Service Bulletin 52

Subject: Sportsman Stabilizer Pin Engagement

Applicability: All Sportsman Aircraft

Figure 1: Ideal Dimensions for Bulkheads D and E

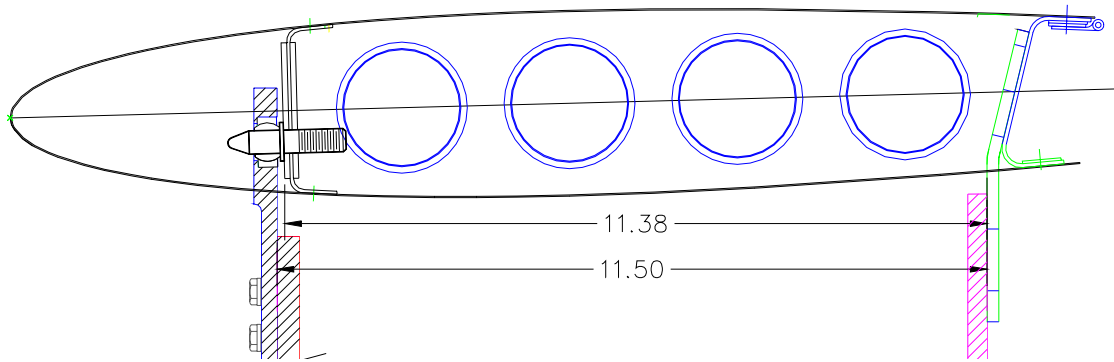
On factory prebuilt fuselage assemblies, the set distance between the aft face of the E-bulkhead and the forward face of the D-bulkhead is approximately 11.56-11.60 inches. A measurement from the forward face of the aft spar attach bracket on the stabilizer to the front face of the forward stabilizer spar build up measures approximately 11-3/8. This is illustrated in Figure 1. Adding the 1/16" thick pin shoulder on the forward side of the front spar and the 1/16" aft protruding shoulder of the spherical bearing to this 11-3/8 gives the ideal D-bulkhead to E-bulkhead spacing of 11-1/2".

Figure 2: Maximum allowed Dimension between Bulkheads D and E

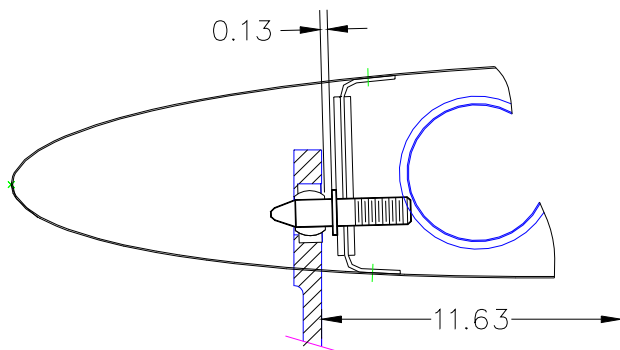
If you cannot make this determination with the mirror, measure the distance between the aft face of the E-bulkhead and the forward face of the D-bulkhead. If your spacing is greater than the 11.63 shown in Figure 2, you must rework your installation in either one of two ways.

If your strakes are not installed on the airplane, you may remove laminates from the aft side of the E-bulkhead in the area under the arms of the attach bracket, until you fall inside the 11.63 minimum dimension. It is recommended you relieve it until the measurement is 11.56. You should then laminate the same thickness of plies (as those that have been removed) on the forward side of the E-bulkhead over an area twice as wide as what was removed.

If your strakes are already installed on the airplane, then you should replace the pins on your horizontal stabilizer with two pins that are longer (302-00011-03). These pins are available through Glasair Aviation. You will need to cut an inspection hole in the bottom of your stabilizer between the two main center ribs to access the nuts on these pins. You may install the same backup ring and cover as that used on the wings, namely the 201-33001-01, 201-33002-01, (4) K-1000-08 and (4) AN526-8R6 fasteners also available through Glasair Aviation.
